RFP #2024-07
ADDENDUM #03
Issued April 25, 2024

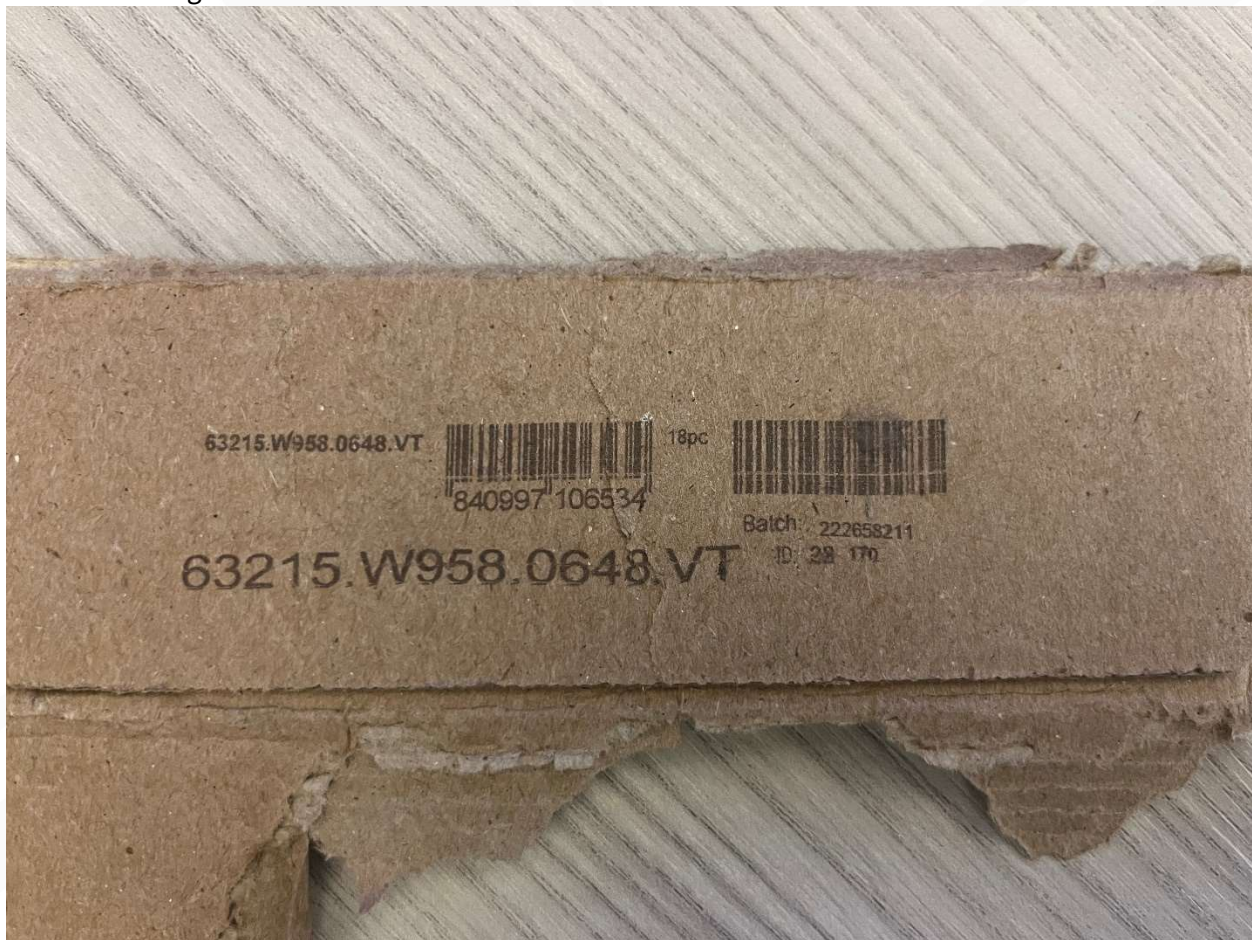
RFI #1

Addendum #02 response #2 to the Laminate spec request references an attached exhibit but the attached exhibit only provides paint colors. There doesn't appear to be any laminate information included.

Response to RFI #1

Please see image below for LVT floor finish.
